Y Barri i Ddinas Powys - Llwybr Teithio Llesol

Adroddiad yr Ymgynghoriad

Vale Velo Ways Response to the Vale of Glamorgan's "Barry East - Active Travel Improvements Consultation"

Figure 1 - Proposed dropped kerb at Biglis roundabout

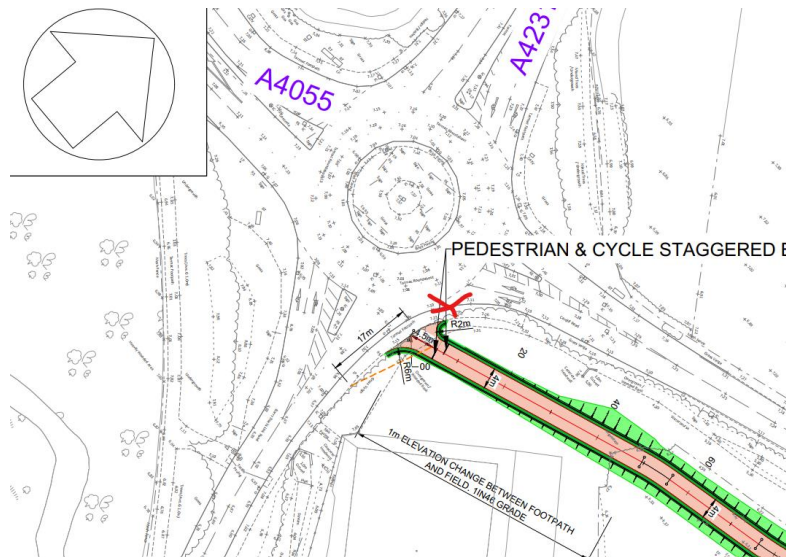
2. Provision for Cyclists Through Cadoxton: Currently, there is no provision for cyclists coming through Cadoxton. A dropped kerb where marked in Figure1 would allow cyclists to maintain flow travelling east from the A4055, round the roundabout, and provide easy access to the start of the track. This also applies to cyclists heading south down the A4231. The access point for many cycle lanes in Barry and the Vale involves an almost 180-degree turn, which slows cyclists down and

increases the risk of being hit from behind and breaches Welsh Government Active Travel design guidance. The guidance emphasises the importance of smooth and direct routes for cyclists to enhance safety and convenience. Smooth and direct junctions are particularly important for non standard cycles.

Ymateb y Cyngor i rif 1 – Diolch i chi am eich cefnogaeth i'r prosiect hwn ac rydym yn croesawu eich cefnogaeth barhaus a byddwn yn gofyn am adborth drwy gamau nesaf y dylunio os bydd cyllid ar gael.
